PRODUCT CHANGE NOTIFICATION

TISP® THYRISTOR SURGE PROTECTORS

Bourns Announces Changes to Select TISP® Thyristor Surge Protector Products

Mold compound, leadframe design and material and carrier tape dimensions

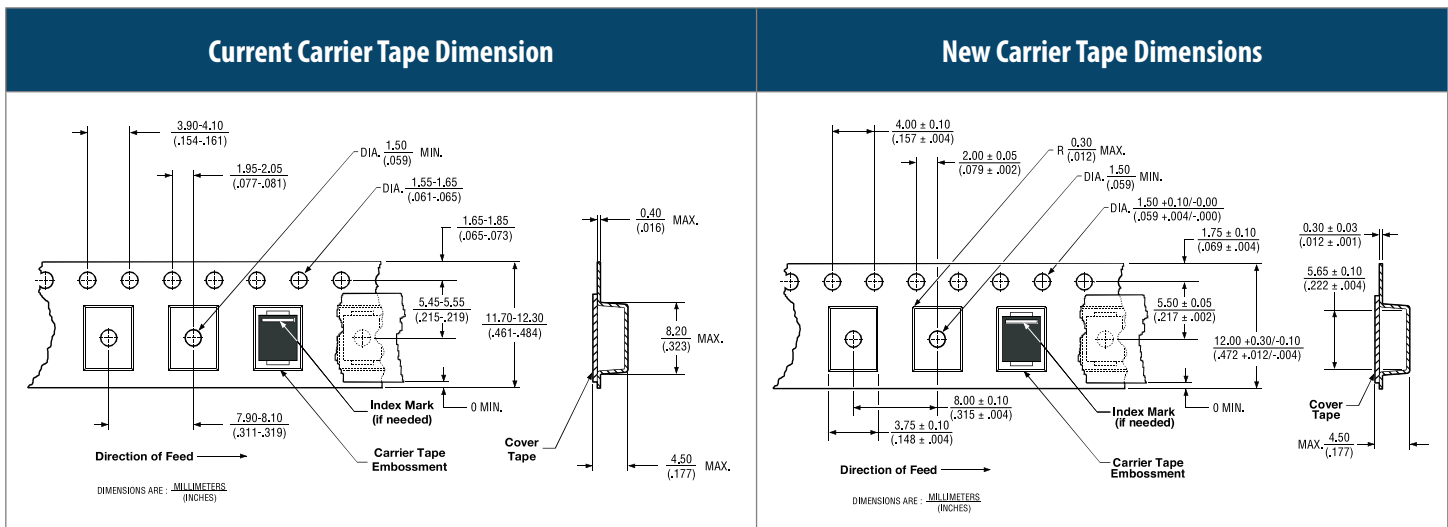
Riverside, California – May 31, 2019 – In the spirit of continuous improvement, effective November 1, 2019, Bourns is changing (i) the mold compound on the SMB (DO-214AA) package to EK3600GH, (ii) the leadframe design and material to C19210, and (iii) the dimensions of the carrier tape for select TISP® Thyristor Surge Protector Products. There is no change to the data sheet rating or electrical characteristics of the products.

These changes have no impact on the form, fit, function, quality or reliability of the affected products. The product marking and label will remain unchanged. The changes to materials, mold compound, leadframe design and material will impact the process for producing the affected parts. The carrier tape dimension changes will affect the fit and form of the packaging as shown.
